London
CANADA

That, the following actions be taken with respect to the 3rd Report of the Environmental and Ecological Planning Advisory Committee, from its meeting held on February 17, 2022:

Adelaide Waste Water Treatment Plant Flood Management EIS

Oxford Street West and Gideon Drive Environmental Assessment (EA) Study's Environmental
Impact Study (EIS)

Figure 9: Tree Preservation and Compensation
(2017 City of London Air Photo)

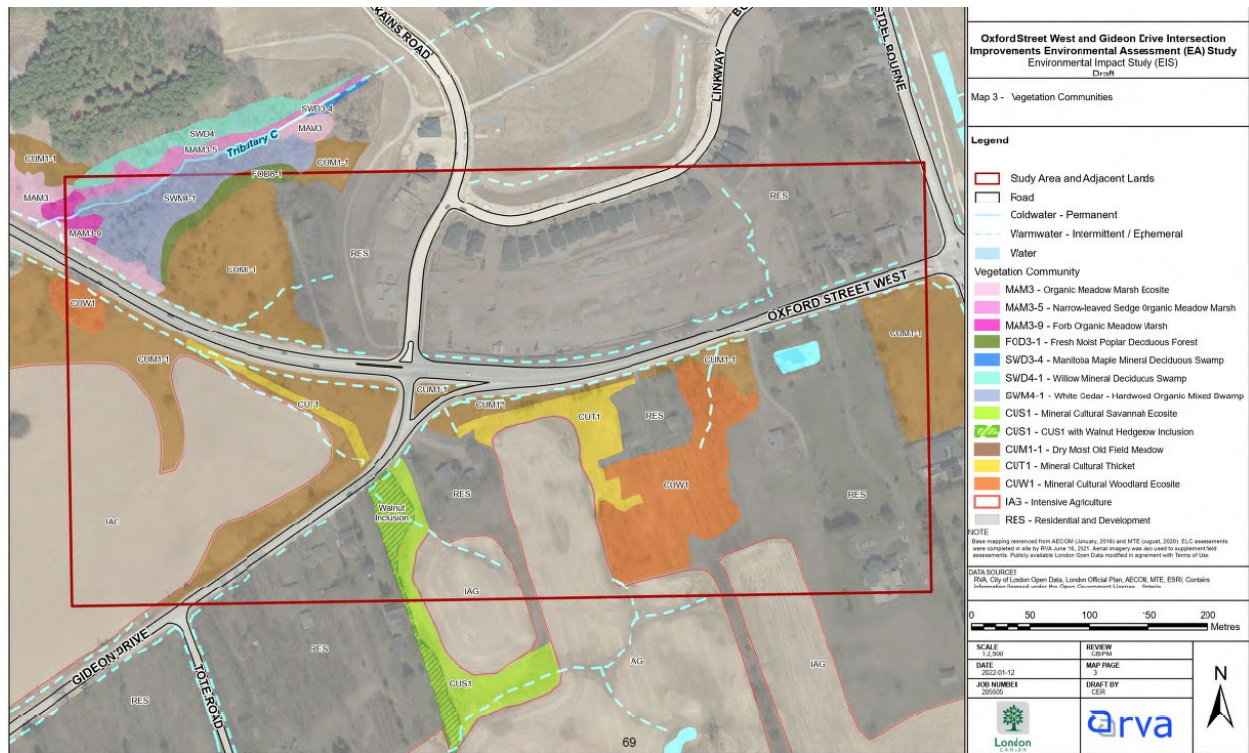
1. This study area includes several species at risk including the Eastern Peewee, which relies on the walnut tree habitat. Based on a previous EA, the walnut inclusion area is being lost. (see Figures 8 and 9 - Figure 3 and 4 below).

An additional 20 trees are targeted for removal. EEPAC recommends walnut trees be avoided. However, if walnut trees are removed how will they be compensated. EEPAC recommends that the species planted must be native. This should improve habitat for woodland birds like the Eastern Wood-Peewee.
